## Presentation to NRC

My name is Ron Black. I am the chairman of the Lea County Commission. I am here tonight speaking on behalf of the Lea County Board of Commissioners and the citizens of Lea County

I want to thank you for being here tonight to gain insight into the viability of the application Waste Control Specialists has filed for the establishment of an interim Storage of Spent Nuclear Fuel facility in our area. Lea County has branded itself as the Energy Plex and we take great pride in the role we play in helping to make the United States self-sufficient in energy. We are one of the most prolific producers of oil and natural gas in the nation. We are also home to the nation's largest uranium enrichment facility, and we are rapidly expanding our footprint in renewable energy in the areas of wind energy, solar energy, and bio-fuels. We understand and support anything that contributes to the nation's energy supply. We also understand that a safe, well planned interim storage facility would be much better than the present system of storing the nuclear waste on site at the nation's power plants.

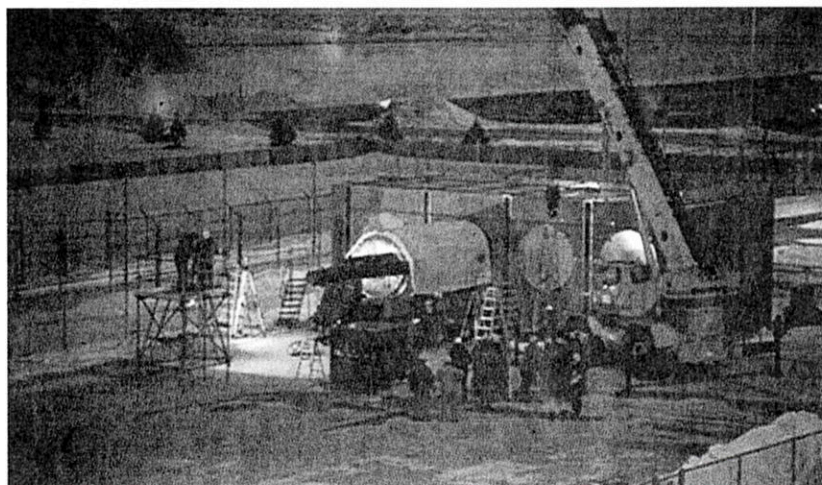
1. The canister loaded with over 10 million curies of radioactivity is housed inside the flat concrete walls that AREVA calls NUHOMS.

Thousands of these NUHOMS houses for the nuclear fuel will be erected by WCS at New Mexico's border with Texas.

These concrete walls are a huge target to a crashing air craft. The result of the crash will be an environmental nightmare for Eunice, Hobbs and our other communities.

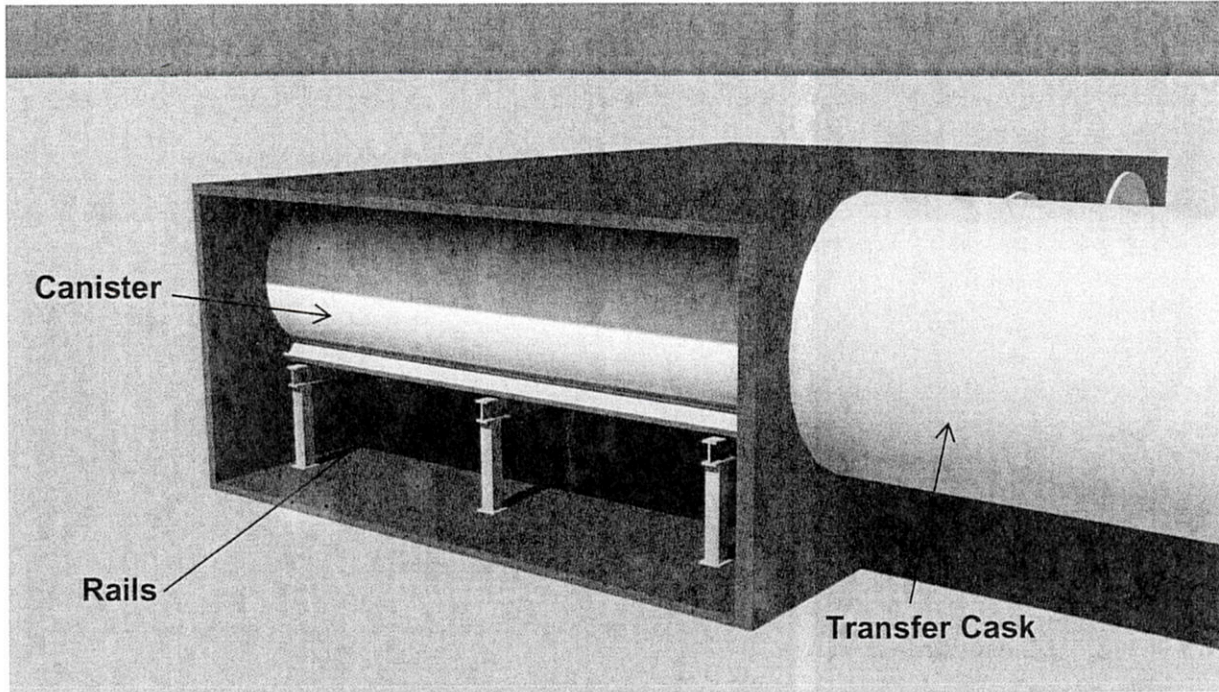
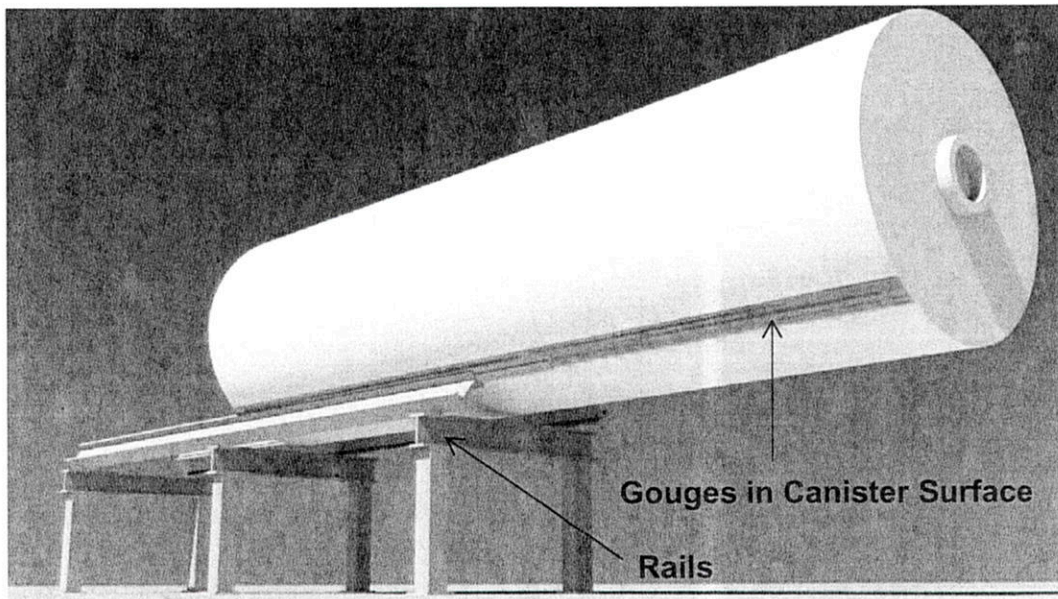
2. Each Canister is a thin walled container weighing over 40 tons. How does Areva install the 40 ton Canister in the NUHOMS houses? By pushing it over a set of rails.

Most every canister surface is gouged as it is pushed even with grease applied on the rails. It will be damaged even more severely again when it is pulled out of storage after the grease has dried up over time by the high radiation...and then again when it is pushed into the NUHOMS module at WCS. A thin walled Canister, gouged again and again, every time it is handled! Can the NRC assure us that none of the thousands of canisters that will be stored at the WCS site will leak?

What will one or more leaky canisters do to our environment?

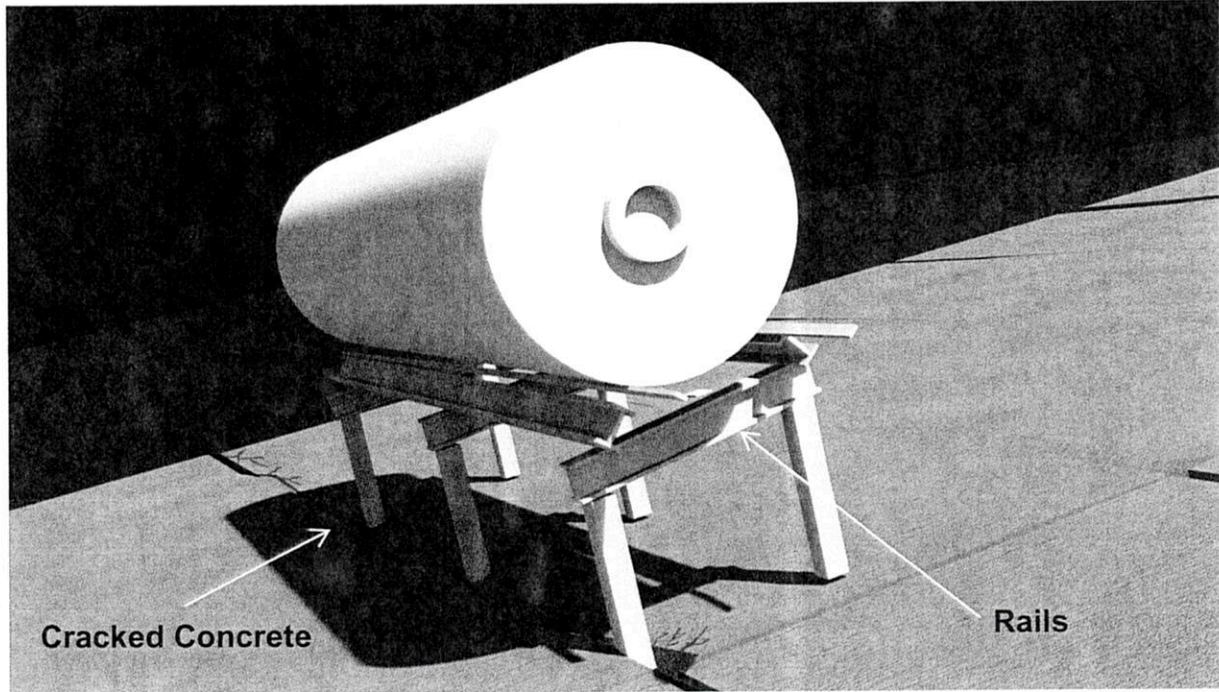
3. WCS calls it Interim storage....what will happen if the slab supporting the support legs that hold the rails settle after years of storage? How will the Canister be dragged out of the NUHOMS if the rails holding the Canister start to deform? Does WCS have a practical recovery plan if the canister cannot be removed? Will the site become a permanent dump?

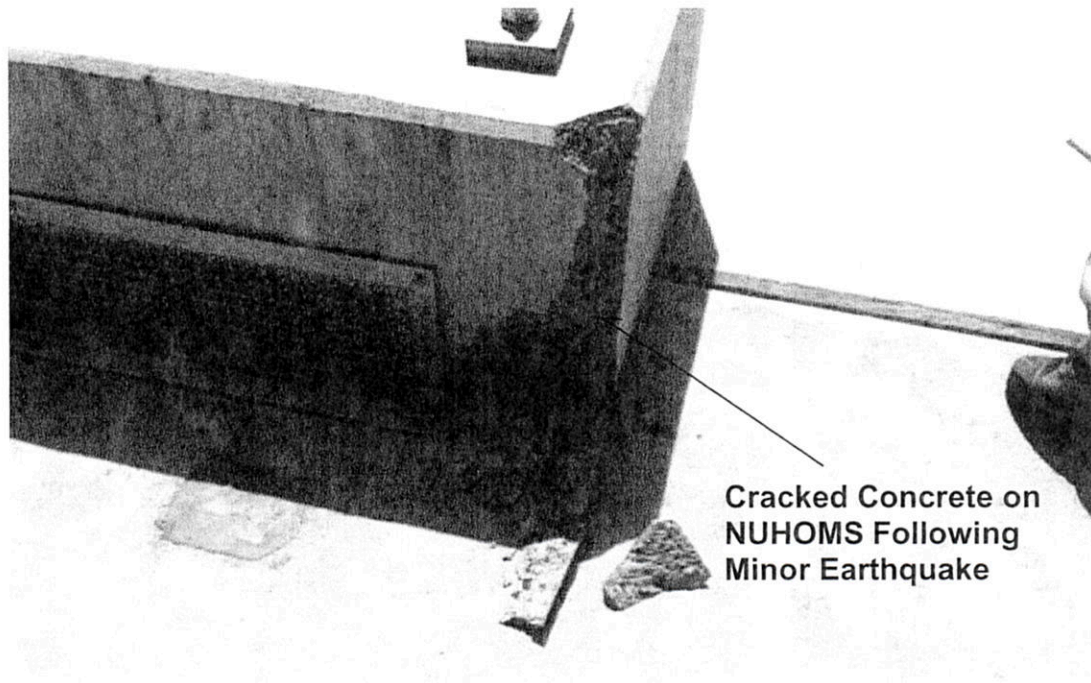
4. We understand a slight earthquake caused damage to the NUHOMS at a Virginia plant in 2011. What will happen if a stronger earthquake strikes? Will the joints at the concrete wall and roof remain intact? Will the rails fail? Will our communities be faced with exposure to deadly radiation?
